Technical Service Bulletin			
Edition: Prelim V2	TSB#: 421 (ECR1699)	Issue date: April, 27, 2022	Page 1 of 2

Title: New Pressure Switch due to EOL

PN6000008_Pressure_Switch		New Version: PN60900101_Pressure_Switch

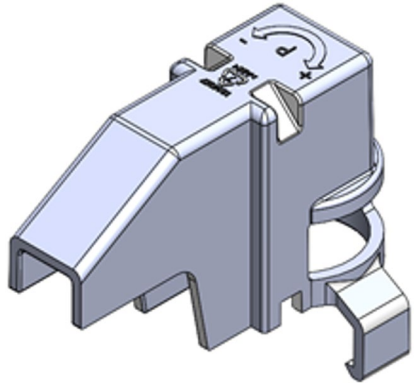
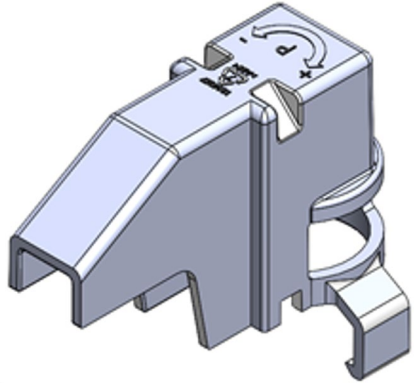
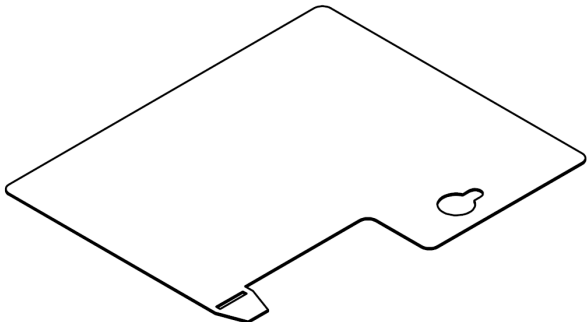
Current presostat PN60000008 is EOL, it will be replaced by PN60900101.
Also change pressure switch cover.

Both pressure switch are fully backwards compatible. The cover is not compatible.

PN1264357_Cap_Pressure_Switch	PN45000070 Heat Shrink Cable ED40*
not compatible with new pressure switch

PN1264357_Cap_Pressure_Switch	PN21001002_Pressure_Switch_Cover
not compatible with new pressure switch 	 *using in production PN45000070 while PN21001002 is not implemented. Use also this Heat Shrink for machines in the field with old PN1264357_Cap_Press_Switch as PN21001002 is not backwards compatible.
